UNITED STATES
DEPARTMENT OF THE INTERIOR
BUREAU OF LAND MANAGEMENT

8. Well Name and No.
LOTOS FEDERAL 8019. API Well No.
30-015-28044-00-S110. Field and Pool or Exploratory Area
WILDCAT11. County or Parish, State
EDDY COUNTY, NM**SUBMIT IN TRIPLICATE - Other instructions on page 2**

Chevron respectfully requests to abandon this well as follows:

**CURRENT
WELLBORE DIAGRAM**

Proposed
WELLBORE DIAGRAM

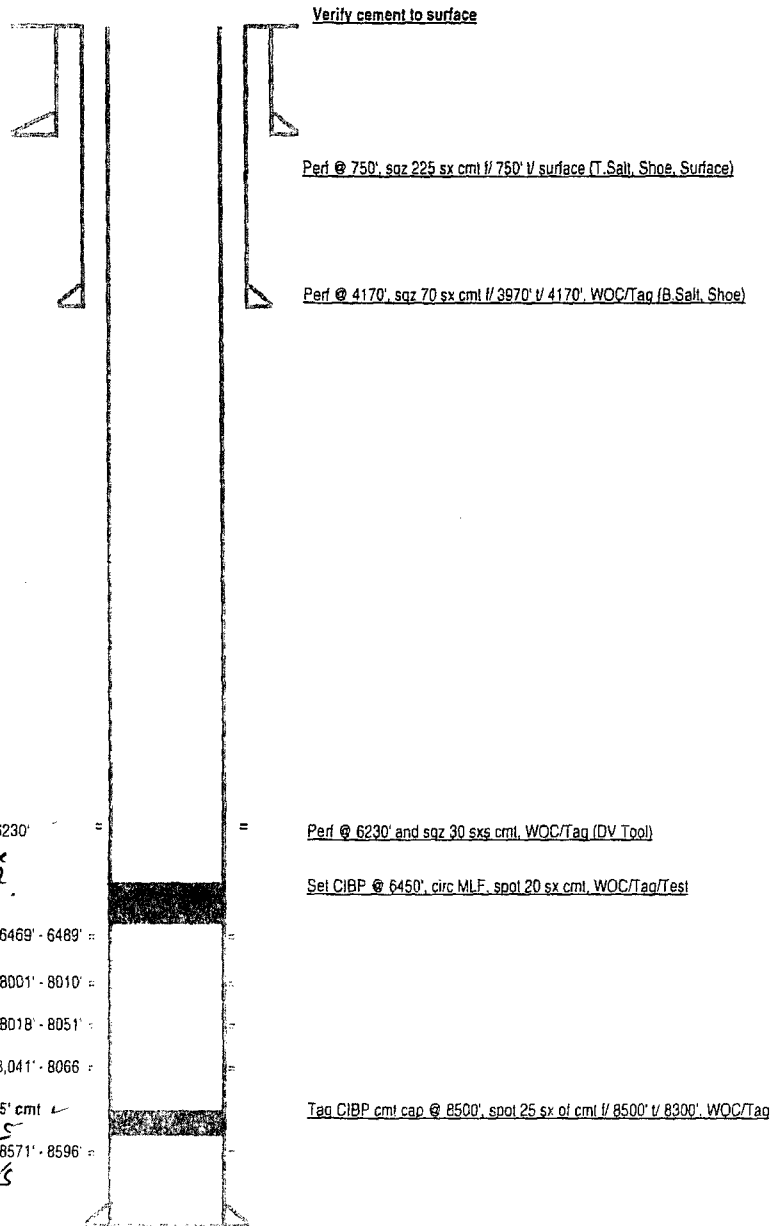
Size: 11 3/4" ✓
 Wt.: 42#, K-55 ✓
 Set @: 630 ✓
 Sxs cmt: 550 sxs ✓
 Cmt Date: 3/21/95 ✓
 Circ: Yes ✓
 Hole Size: 14 3/4" ✓

Size: 8 5/8" ✓
 Wt.: 24#, K-55 ✓
 Set @: 4117 ✓
 Sxs Cmt: 1550 sxs ✓
 Cmt Date: 3/29/95 ✓
 Circ: yes ✓
 Hole Size: .11 ✓

Size: 5 1/2" ✓
 Wt.: 17#, J-55 ✓
 Set @: 8772 ✓
 Sxs Cmt: 1405 sxs ✓
 Cmt Date: 4/9/95 ✓
 Circ: No TOC @ 4334' via CBL 5/5/95 ✓
 Hole Size: 7 7/8 ✓

780'-880' T.Salt

Rustler 602

Anhy

Del. 4216

BC4N 6449

B/S 8100
